OXFORDSHIRE COUNTY COUNCIL'S RESPONSE TO CONSULTATION ON THE FOLLOWING DEVELOPMENT PROPOSAL

Application No: 19/02550/F

Proposal: Redevelopment of part of golf course to provide new leisure resort (sui generis) incorporating waterpark, family entertainment centre, hotel, conferencing facilities and restaurants with associated access, parking and landscaping

Location: Land to the east of M40 and south of A4095, Chesterton, Bicester, Oxon

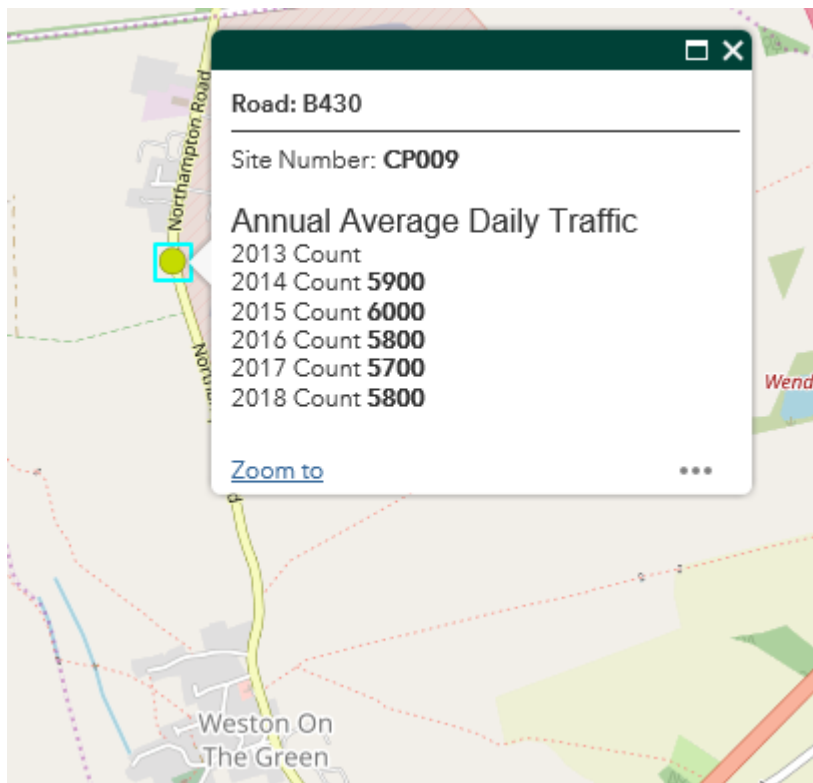
The average two-way flow on the A4095 through Chesterton, between the hours of 06:00 to 22:00, is 5,312 vehicles. This is taken from the data recorded by an Automated Traffic Counter over the five months, January to May 2019.

The maximum predicted daily flow due to the development, through Chesterton, is 552 cars. (This is robust as it assumes 50% of M40 cars from the south take the A41, rather than following signage via the A34/B430). Therefore, the maximum predicted traffic increase equates to 46 per hour when averaged over a 12-hour period. The figures for the peak hours are lower than the average (32 in the morning peak and 44 in the evening) as the majority of guest trips will take place between 9am and 2pm. Nearly all additional vehicle movements will be private cars as there will be few HGV trips associated with the development.

There is a build-out traffic calming feature on the northern edge of the village that requires incoming vehicles to give-way to outbound traffic. It is understood this feature can cause considerable delays, particularly in the morning when two-way flows over 800 vehicles have been recorded between 7:00 and 8:00, with the majority of vehicles heading into the village. Peak evening total flows are approximately three-quarters of the morning flows, with the primary direction of travel reversed. As noted above, additional traffic associated with the development will tend to be mainly outside of the peak hours and will, therefore, not have a significant effect on the queuing at the build-out.

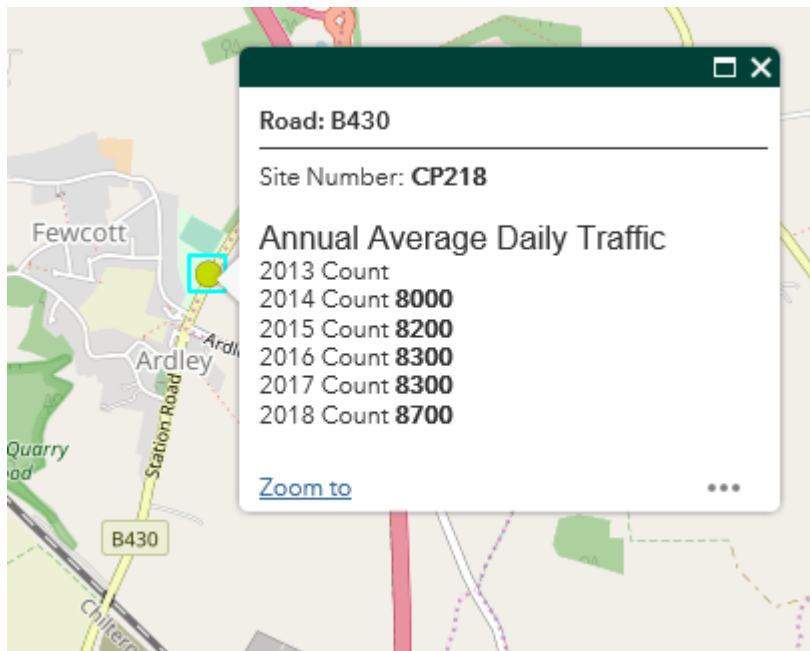
The average two-way flow on the B430 through Weston-on-the-Green, over the last five years, is 5,840 vehicles. The maximum predicted daily flow due to the development is approximately 834 cars, leading to an increase of 14.3%. If all M40 northbound development traffic were to follow the signed route via the A34/B430 then an additional 400 cars approximately would pass through Weston-on-the-Green, leading to an increase of 21%.

The B430 occasionally accommodates significant traffic volumes that re-route due to incidents or blockages on the M40 or Junction 9, with daily flows up to 12,500 having been recorded. Although the percentage increase is greater than the A4095, the effect of the development traffic on the B430 is not considered to be sufficiently severe to justify an objection. OCC agree that the proposed signage strategy is the most appropriate and will more evenly distribute the additional traffic, should the application be permitted.

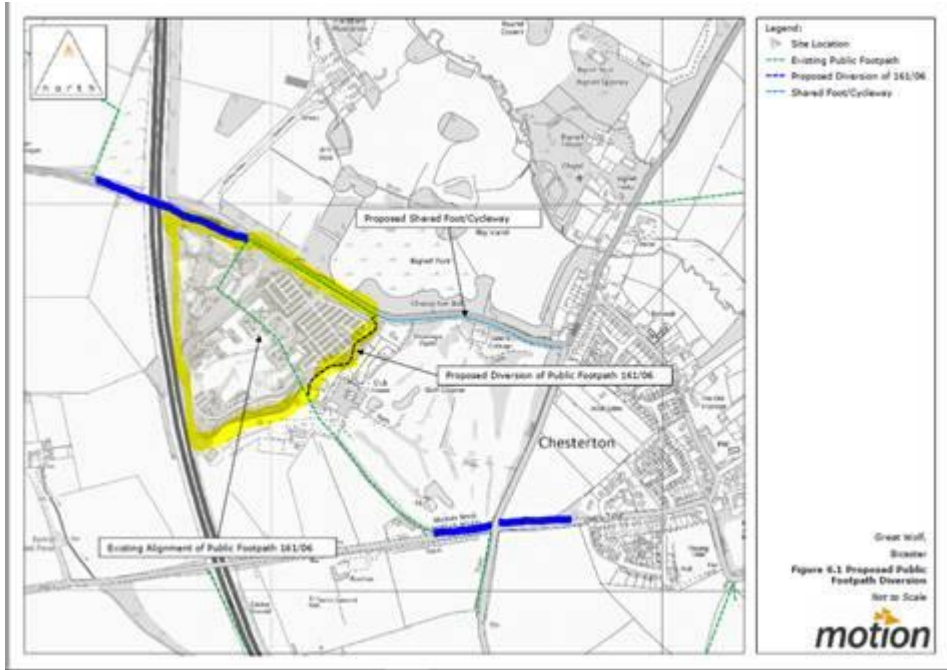
A bus service to/from the proposed Chesterton facility does not need to have an inter-urban element, but it does need to connect with the national rail network (at one or both Bicester rail stations) and with the regional bus network (at Manorsfield Road). It does need to operate at least hourly at regular memorable intervals, which could permit operation through some residential areas of Bicester, as required. Also it does need to operate until late evening, to take staff working evening shifts at the various facilities on site back to Bicester (again, note the 0035 departure from Centre Parcs in Cumbria, which is presumably specified to perform this function, seven nights per week). The bus service to this site does not necessarily need to be free to users, as this would work against the longer-term sustainability of the public transport service. A suitable covered bus stop would be required in a convenient location within the resort, and the movement of an appropriate vehicle through the site would need to be demonstrated by a swept path analysis.

The application proposes two separate shuttle bus services, one for guests and the other for staff and local residents. The former is proposed to run on a two-hour basis, which will not be attractive to many of the guests who arrive by rail as they may have a significant wait. Similarly, it is suggested that the staff bus will run only to coincide with the start and finish times of the main shifts, whereas a public bus service would provide a benefit over a greater portion of the day.
